**SERVICE BULLETIN**

**N° 109EP-178**

**ATA 31 – SLIDING SCREEN INSTALLATION**

The purpose of this Service Bulletin is to install the sliding glare shield on the instrument panel shield hood Assy.

**Figure 5**

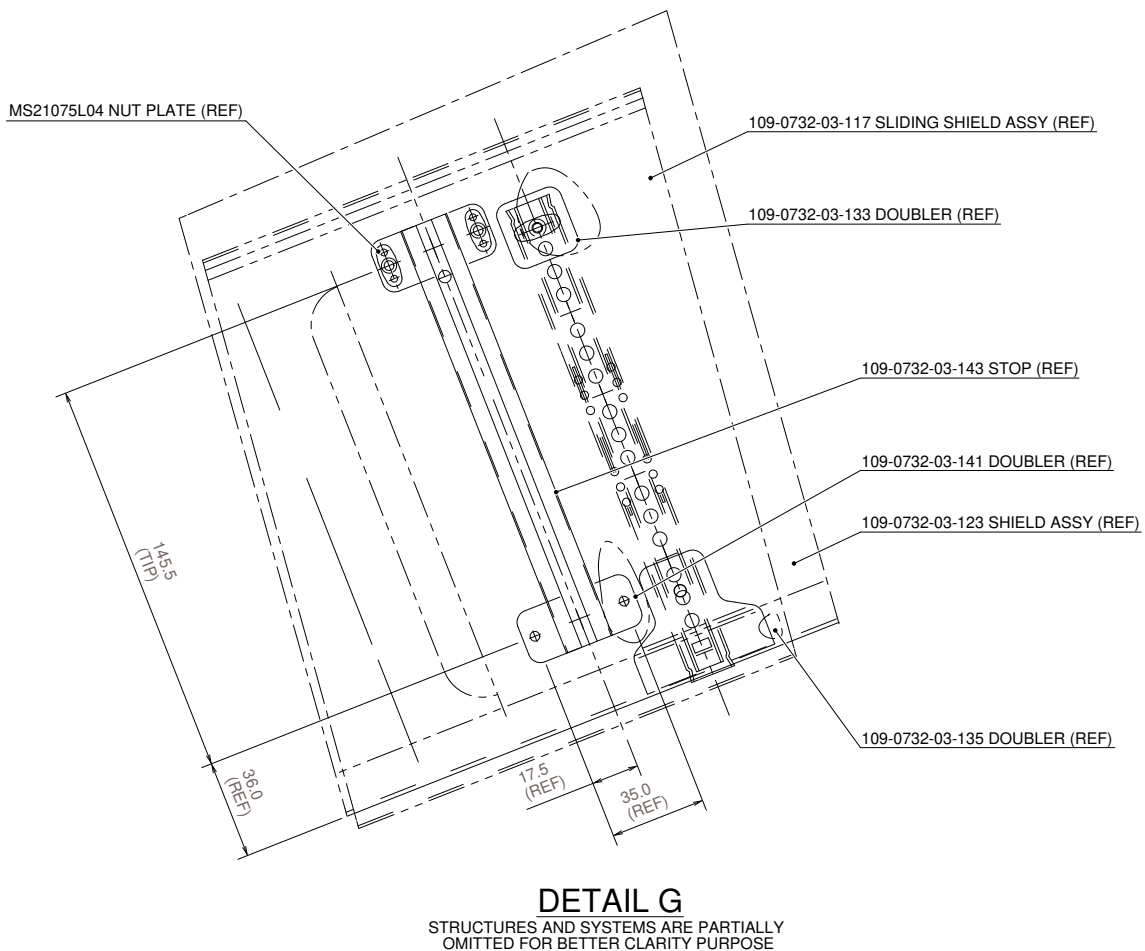
- 5.5 With reference to Figure 5, drill n°4 nut plate holes  $\varnothing$  3.68÷3.81 on the shield assy P/N 109-0732-03-123.
- 5.6 With reference to Figure 5, drill n°4 through holes  $\varnothing$  4.20÷4.50 on the shield assy P/N 109-0732-03-123.
- 5.7 With reference to Figure 5, install n°4 doublers P/N 109-0732-03-133 and n°4 nut plates P/N MS21075L06 by means of n°8 rivets P/N MS20426AD3-7.

- 5.8 With reference to Figure 5, drill n°8 nut plate holes  $\varnothing$  3.25÷3.85 on the shield assy P/N 109-0732-03-123.
- 5.9 With reference to Figure 5, install n°4 doublers P/N 109-0732-03-141 and n°8 nut plates P/N MS21069L04 by means of n°16 rivets P/N MS20426AD3-7.
- 5.10 With reference to Figure 5, install n°2 stops P/N 109-0732-03-143 by means of n°4 rivets P/N MS20470AD3-7 according to the positions of the doubler P/N 109-0732-03-141 on the shield assy P/N 109-0732-03-123.

**Figure 6**

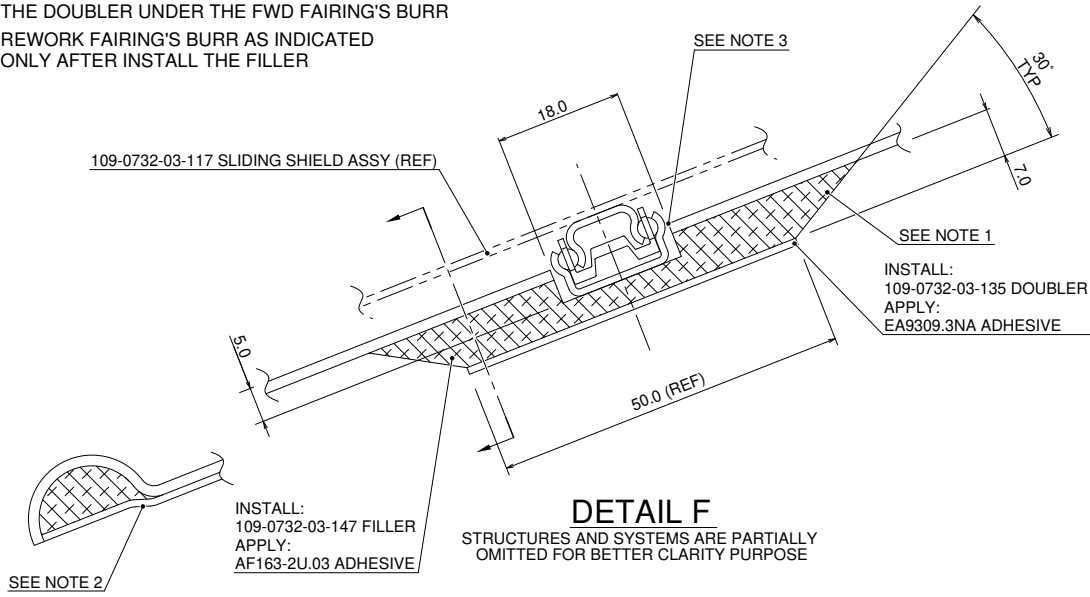
- 4.3 With reference Figure 7, mark the sliding shield assy with P/N 109-0732-03-117.
5. With reference to Figures 4 thru 6, assemble the light shield assy P/N 109-0732-03-111 as described in the following procedure:
- 5.1 With reference to Figure 6 Detail F, install the filler P/N 109-0732-03-147 by means of adhesive AF163-2U.03 (C275) on the shield assy P/N 109-0732-03-123.
- 5.2 With reference to Figure 6 Detail F, rework the shield assy P/N 109-0732-03-123 as indicated in n°4 places according to the position of the sliding guides P/N 109-0732-03-145 installed on the shield assy P/N 109-0732-03-117.
- 5.3 With reference to Figure 6 Detail F, apply adhesive EA934.NA (C054) on the edges of the filler P/N 109-0732-03-147. Smooth with abrasive paper and touch up with the same colour of the shield assy P/N 109-0732-03-123.

- 5.4 With reference to Figure 6 Detail F, install the doubler P/N 109-0732-03-135 by means of adhesive EA9309.3NA (C100) on the filler P/N 109-0732-03-147.

- ① APPLY ADHESIVE EA934.NA  
SMOOTH WITH ABRASIVE PAPER  
TOUCH UP WITH SAME COLOUR OF FAIRING HOOD ASSY
- ② IF NECESSARY LOCALLY ADAPT TO INSTALL  
THE DOUBLER UNDER THE FWD FAIRING'S BURR
- ③ REWORK FAIRING'S BURR AS INDICATED  
ONLY AFTER INSTALL THE FILLER

**Figure 7**

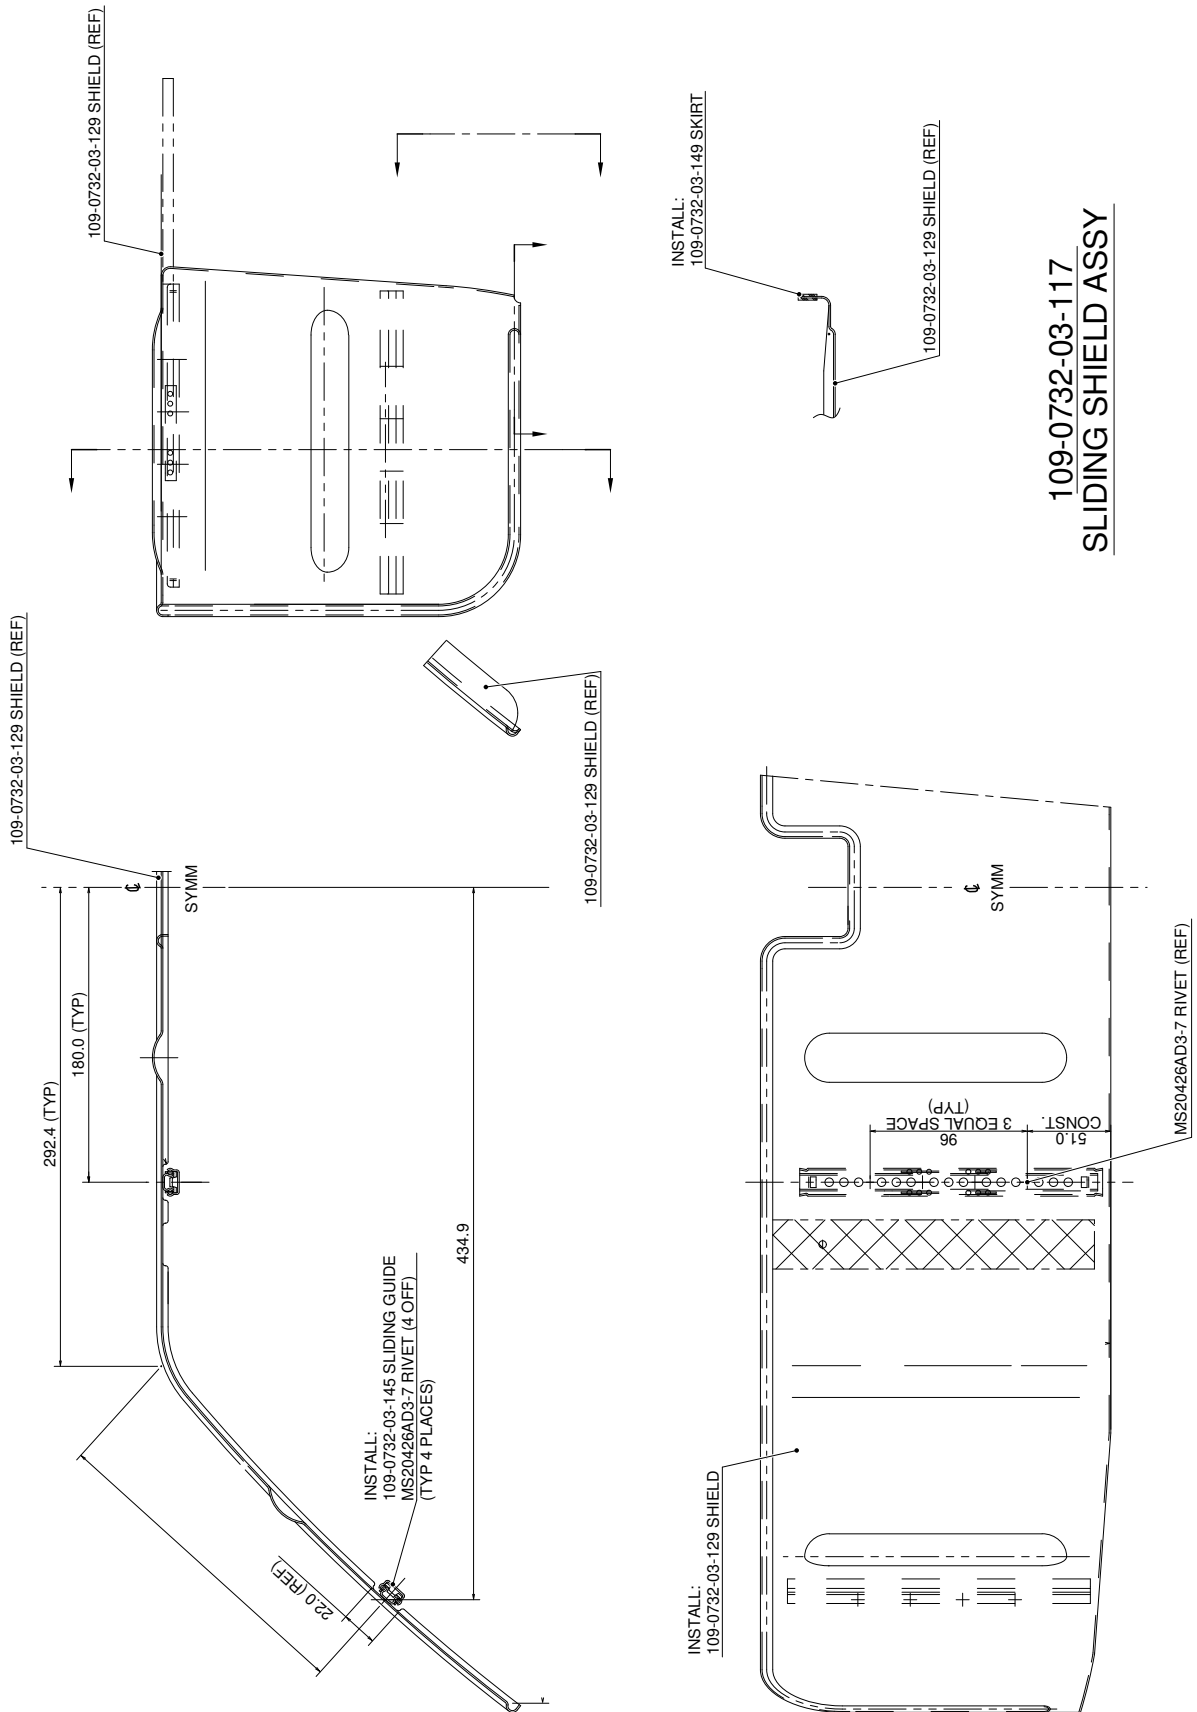
4. With reference to Figure 7, assemble the sliding shield assy P/N 109-0732-03-117 as described in the following procedure:
    - 4.1 With reference to Figure 7, install n°4 sliding guides P/N 109-0732-03-145 on the shield P/N 109-0732-03-129 by means of n°16 rivets P/N MS20426AD3-7.

- 4.2 With reference to Figure 7, install the skirt /N 109-0732-03-149 on the shield P/N 109-0732-03-129.
